9.0 TRANSMISSION SYSTEM RESPONSES

Figure 9-1 Letter from California ISO

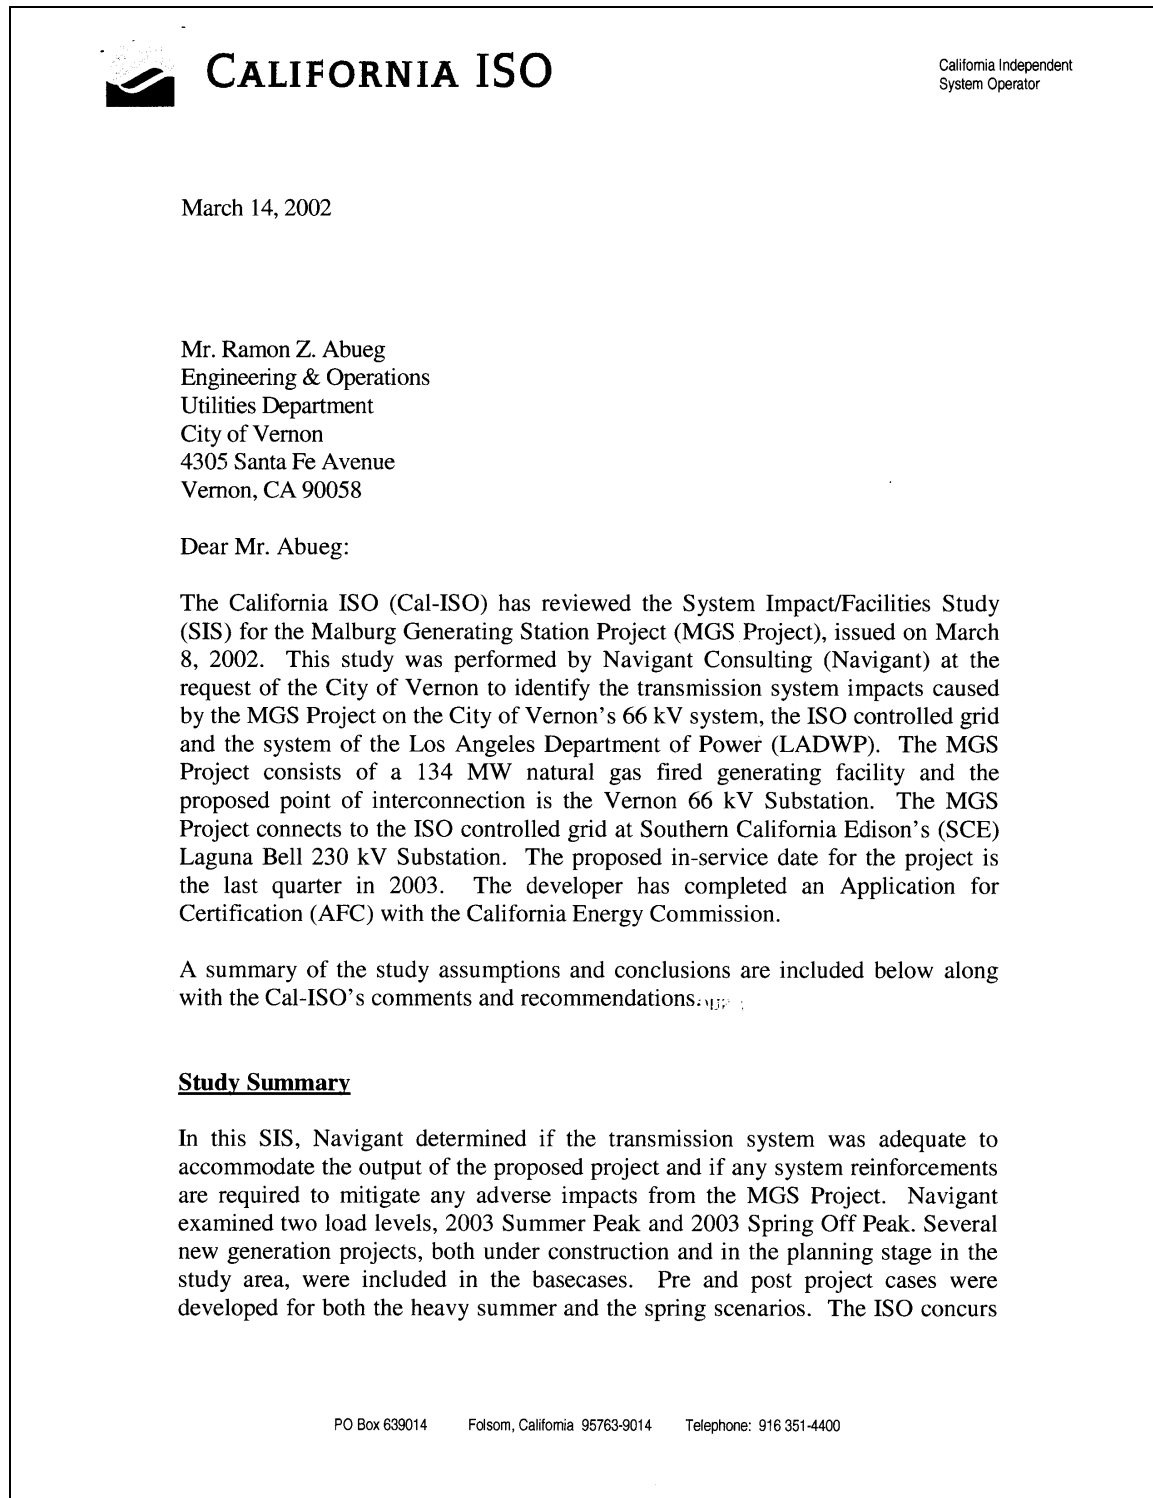
Indicate when preliminary approval from California Independent System Operator will be obtained on completion of the new impact study.

The System Impact Study report was submitted to the CAL-ISO. CAL-ISO staff has approved the results presented in the SIS report. The CAL-ISO letter is reproduced in Figure 9-1.
